USGS REPORT: WHITE MESA URANIUM MILL

Utah Division of Radiation Control
Public Presentation, Blanding Utah
July 9, 2012

- USGS Scientific Information Report, SIR-2011-5231

USGS SIR, Fig. 19

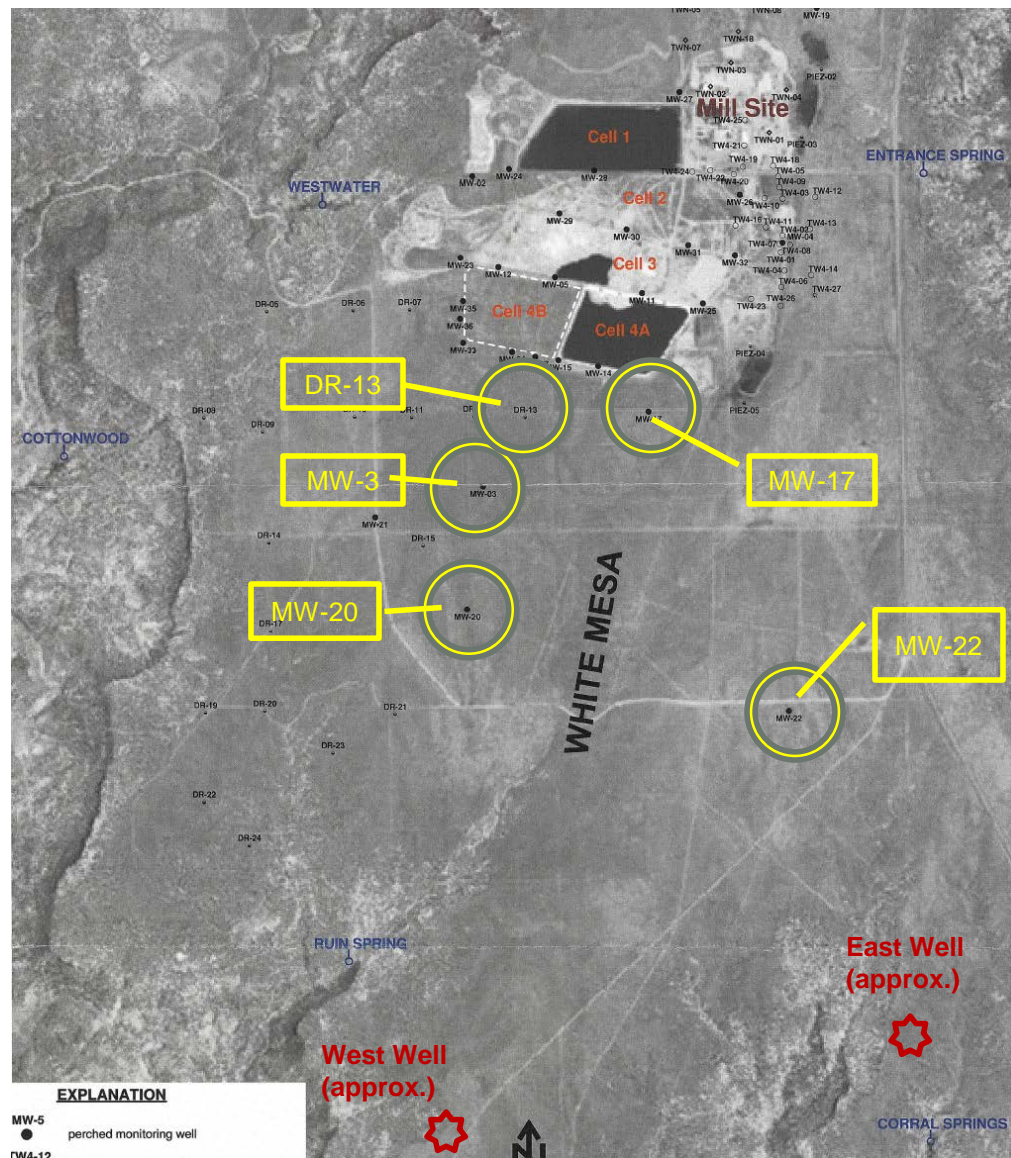
- USGS No. 6:
 - Installation of new monitoring well(s)
 - Upgradient of East and West wells
 - Tribe installed on BLM land
 - Early warning

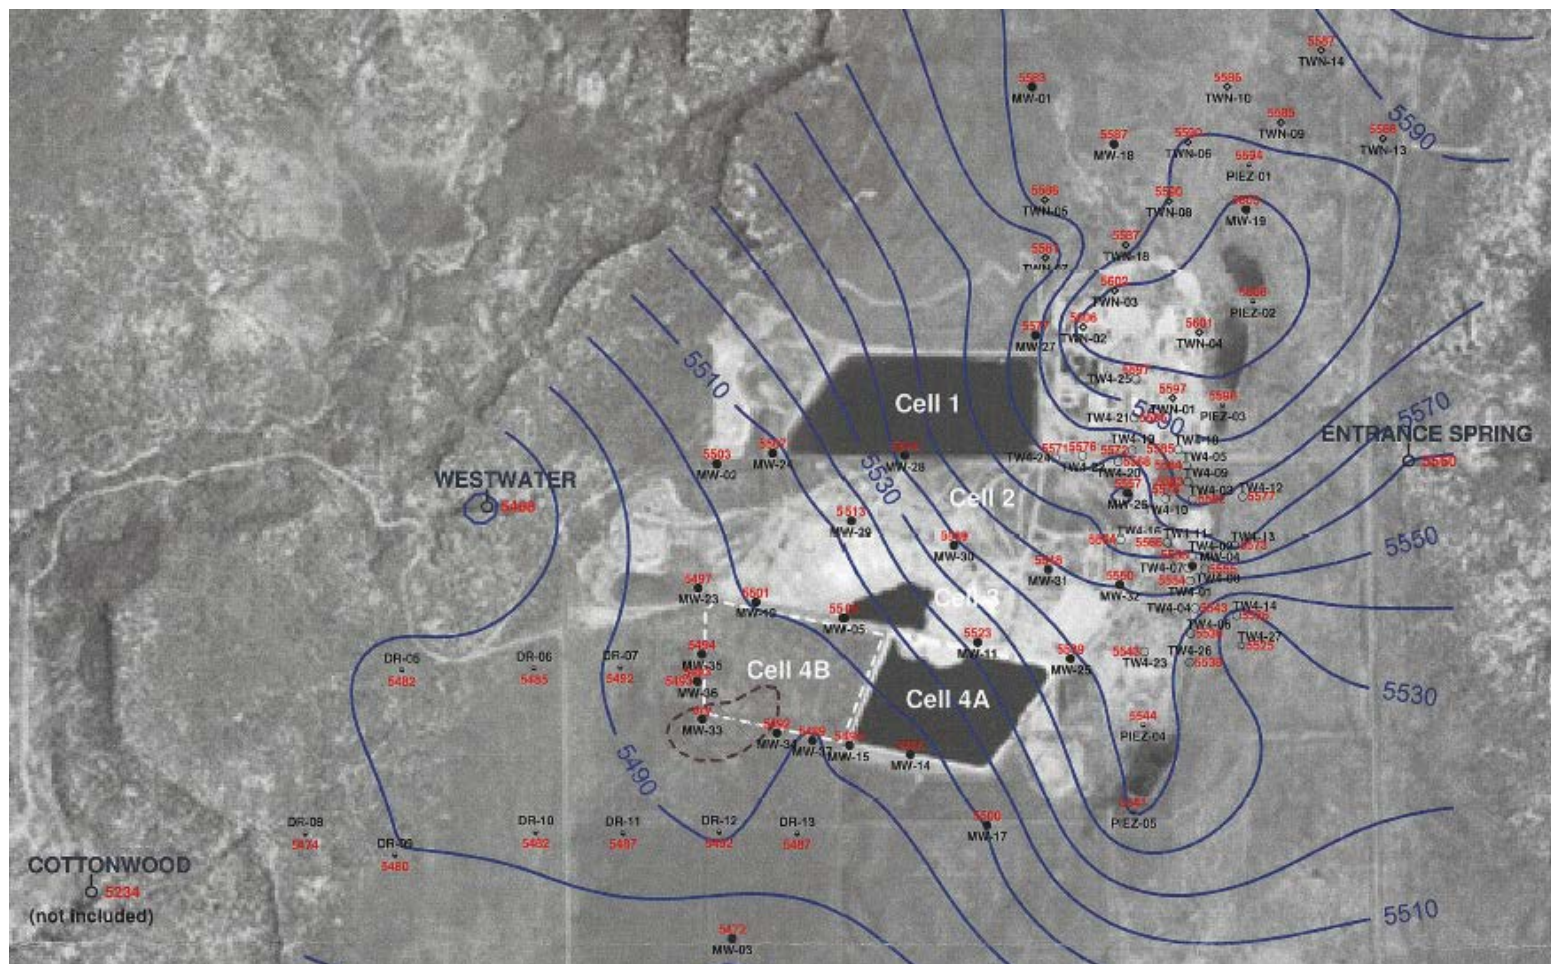
- USGS No. 8 - *continued*

DRC Disagrees because:

- Isotopic analysis
 - Few, if any, standardized methods in Environmental Industry
 - Few laboratories in USA (largely universities)
- Mixed Signals: $\delta^{34}\text{S}$, $\delta^{18}\text{O}$, and $\delta^2\text{H}$
 - DUSA Northwest Wildlife Pond (NWP):
 - Fed by Recapture Reservoir
 - Leaks to Shallow Aquifer (groundwater mound in mill area)
 - NWP $\delta^{34}\text{S}$ Signal: same as tailings wastewater (U. of Utah)
 - ❖ 3 possible transfer mechanisms
 - Ore storage pad runoff – discharge into NWP
 - Air deposition - tailings aerosols
 - Sulfuric acid emissions – mill stacks

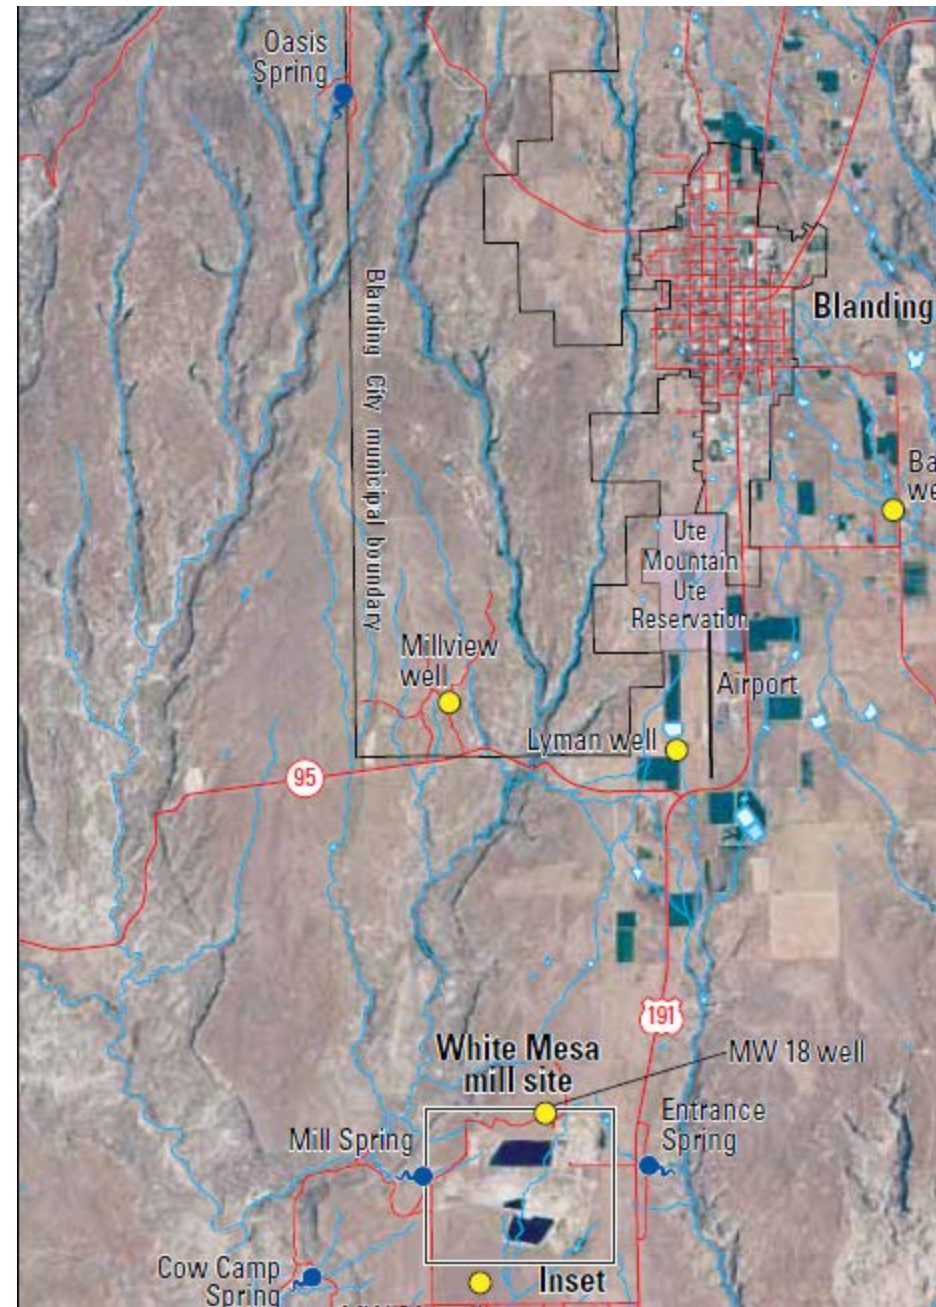
1. Annual monitoring at Oasis Spring needed
 - Field Parameters, Major & Trace Elements
2. Millview Well: Needs to be re-drilled
Annual Sampling

DRC Response:

1. Oasis Spring & Millview Well = good location for background
2. Oasis Spring: Low flow (difficult to find in June, 2012)
3. Millview Well – likely a more reliable water source
 - a) Re-drill Funding?
 - BLM
 - EPA
 - Tribe

2/07 DUSA License Renewal Application, Fig. 6.5-1

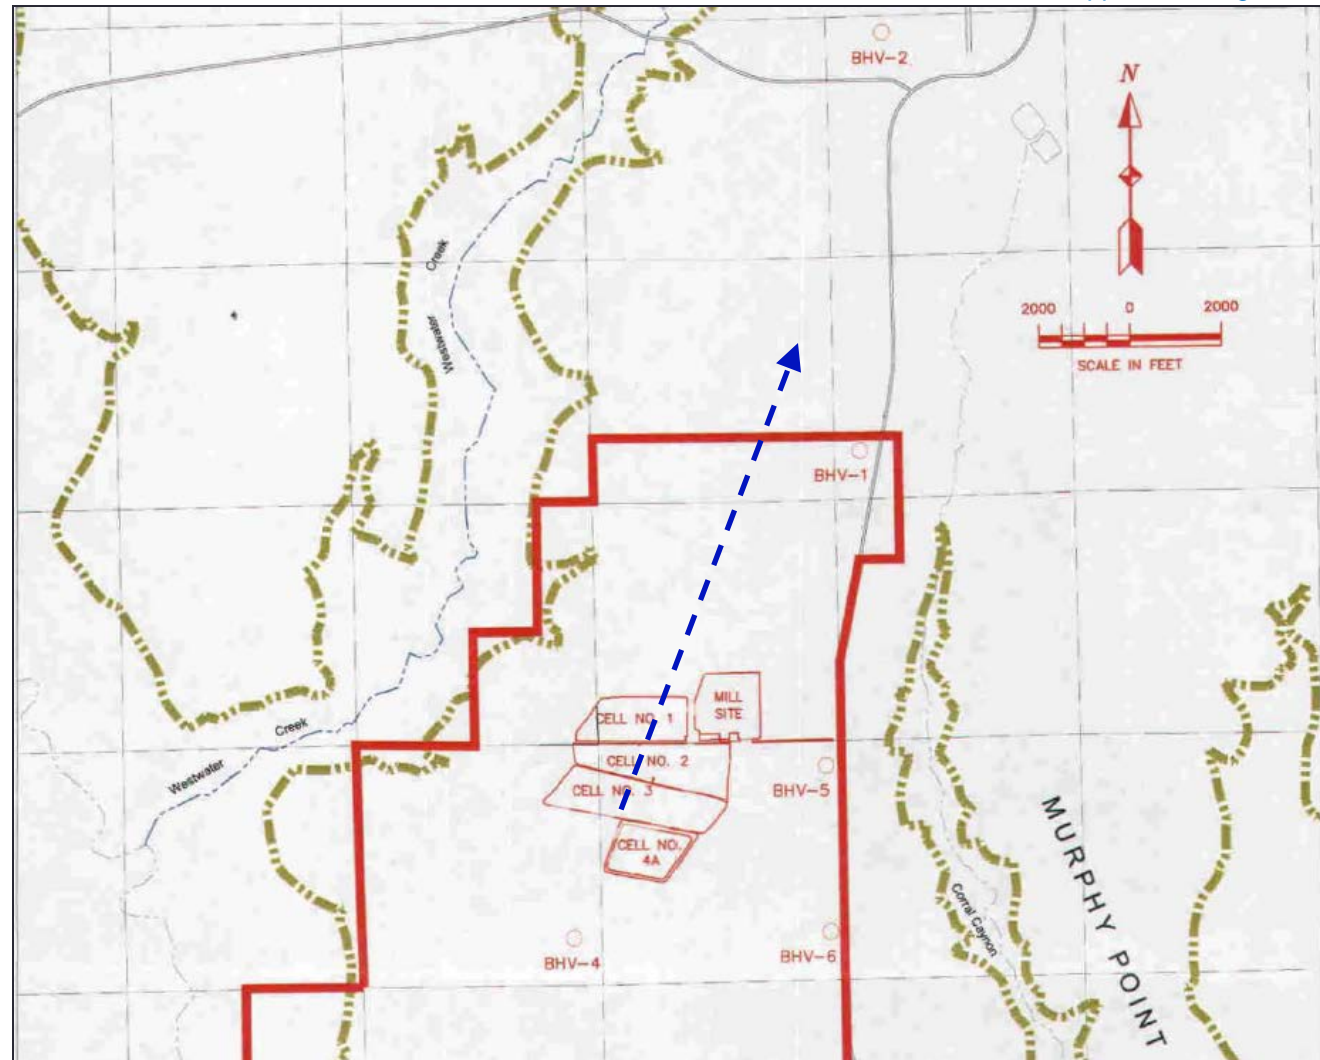
- USGS No. 4

DUSA HVA Air
Monitoring Stations

Prevailing
Wind Direction
(to NNE)

USGS SIR, Fig.32

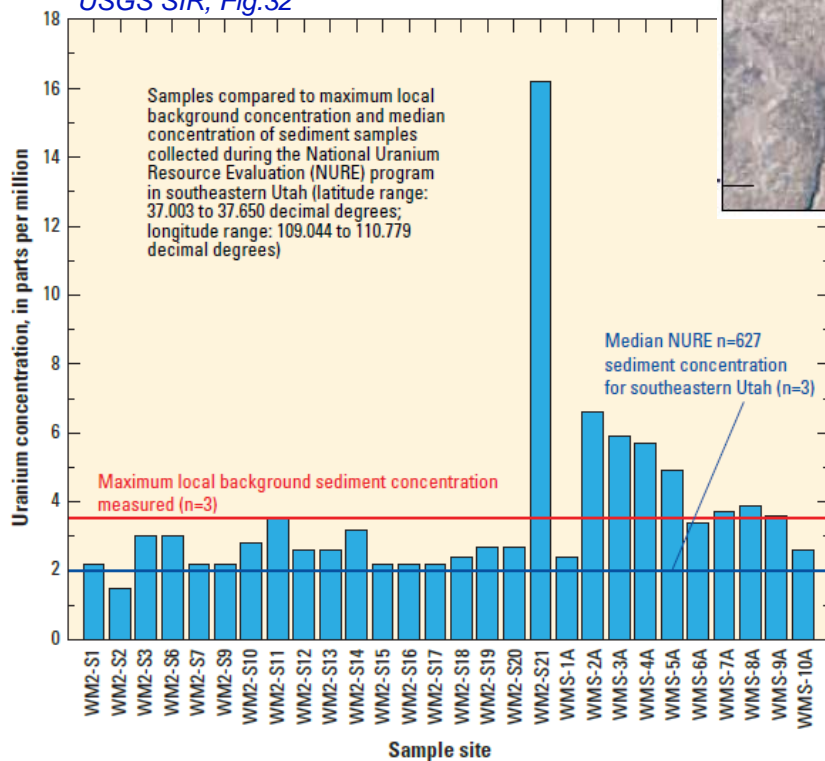
East of Mill Area:

7/10 samples > soil BG for U (3.6 ppm)

USGS Hypothesis:

Dust emissions & stormwater transport

Alternative: ore truck spills / emissions
